SnailPulse Project for Orbita 2026 Season

Rev C: heartbeat-only, heater and thermistors removed
Made by Azizbek N
find out more about this project in this repo:
https://github.com/notazizelse/Orbita26
NazarX

Title: SnailPulse for International Space Competition Orbita

Size: A4	Date: 2026-10-24	Rev: C
KiCad E.D.A. kicad-cli 7.0.11+dfsg-1build4		Id: 1/1

Rev C notes

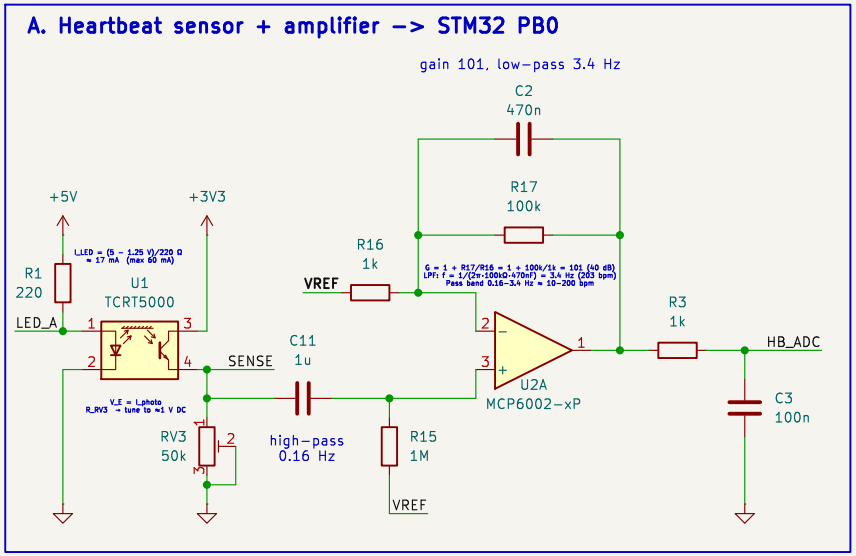
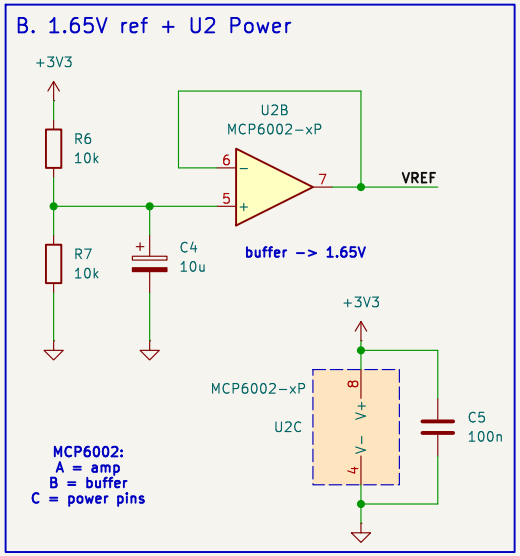
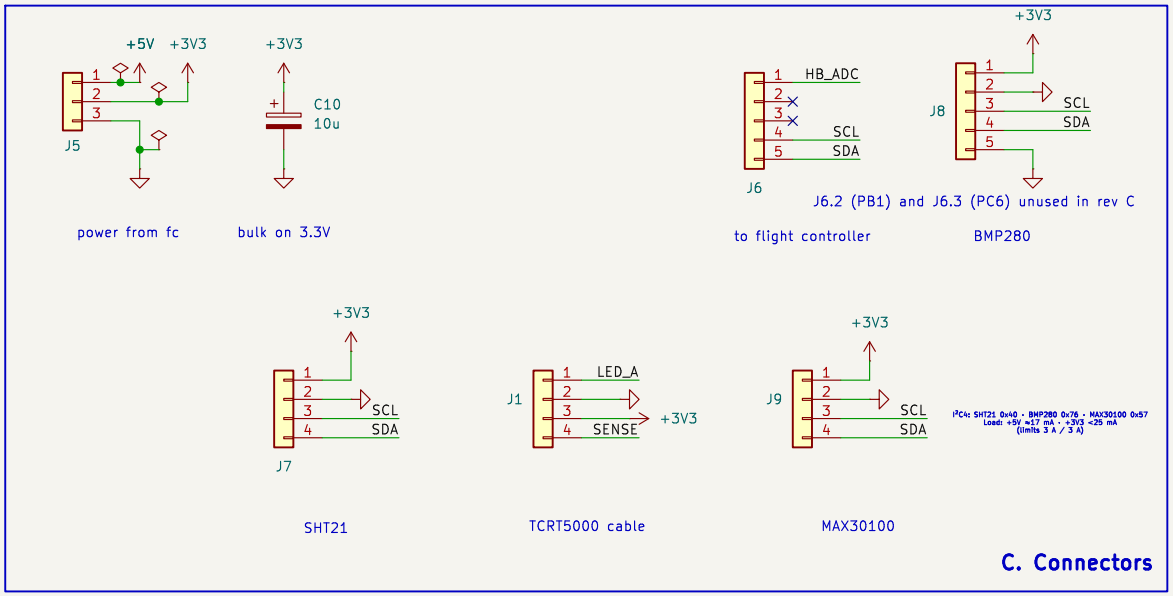
Rev C (24 Oct 2026): heartbeat only

Removed: heater switch (Q1, R8–R12, C6, J2 XT30, J3), thermistors + overheat cutoff (U5 LM393, TH1, TH2, R13, R18, RV2, C7–C9, J4) and the GNDPWR net tie (NT1). Box heating is handled by the other experiment.

Board now needs only +5V, +3V3, GND from the FC. Signals to FC: PB0 = HB_ADC, PD12/PD13 = I2C4.
